UNITED STATES  
ATOMIC ENERGY COMMISSION  
WASHINGTON, D.C. 20545

Change No. 21  
License No. DPR-6

ATTACHMENT A  
CHANGE NO. 21 TO TECHNICAL SPECIFICATIONS  
FACILITY LICENSE NO. DPR-6  
CONSUMERS POWER COMPANY  
DOCKET NO. 50-155

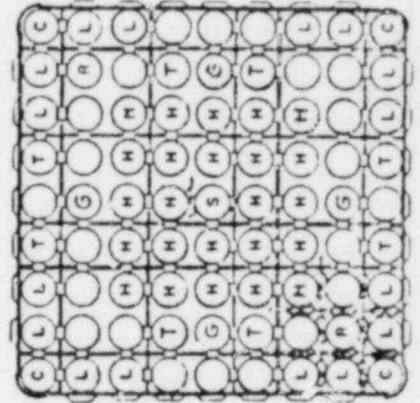
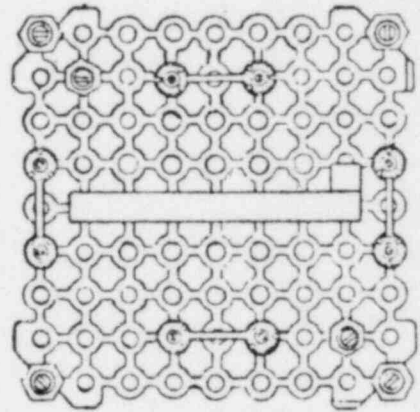
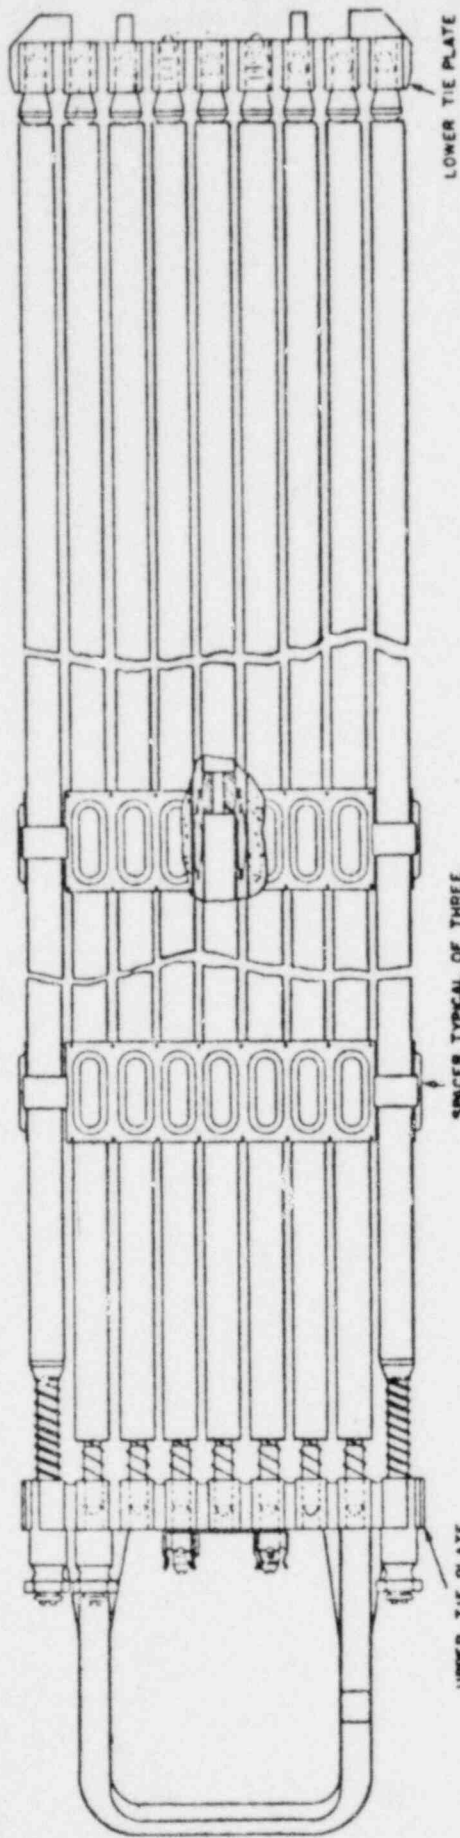
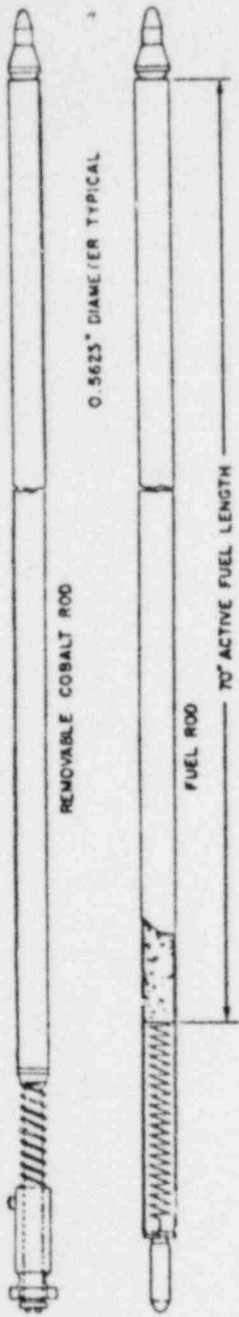
According to the proposed changes, the differences between Reload-F and E-G fuel are small variations in the fuel and poison distribution and repositioning of the four tie rods in the Reload-F fuel assemblies. The difference between the "Type J-1" fuel assemblies provided by Jersey Nuclear Company and the approved E-G fuel assemblies fabricated by General Electric is the use of short diffusers in the "Type J-1" fuel at the tie plate inlet to streamline the flow after the coolant leaves the flow distribution orifices.

D. Add the attached Figure 5.5, "Reload-F fuel"
